UNITED STATES PATENT AND TRADEMARK OFFICE

APPLICATION NO.	FILING DATE	FIRST NAMED INVENTOR	ATTORNEY DOCKET NO.	CONFIRMATION NO.
10/579,312	05/16/2006	Herbert Lifka	NL 031357	1720
24737 7590 11/26/2008 PHILIPS INTELLECTUAL PROPERTY & STANDARDS P.O. BOX 3001 BRIARCLIFF MANOR, NY 10510				
EXAMINER DIAZ, JOSE				
ART UNIT 2879		PAPER NUMBER		
MAIL DATE 11/26/2008		DELIVERY MODE PAPER

Office Action Summary

DETAILED ACTION

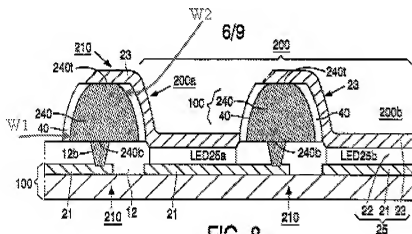
Regarding **claim 16**, Childs clearly shows and discloses that near edges of the display panel, a first width (W1, as pointed out by the examiner below) of said barrier structures (240) is larger than a second width (W2, as pointed out by the examiner below) of said barrier structures (240) at inner portions of the display panel (Fig. 8).

Regarding **claim 17**, Childs clearly shows and discloses that near edges of the display panel, a first width (W1, as pointed out by the examiner above) of said barrier structures (240) is larger than a second width (W2, as pointed out by the examiner above) of said barrier structures (240) at inner portions of the display panel (Fig. 8).
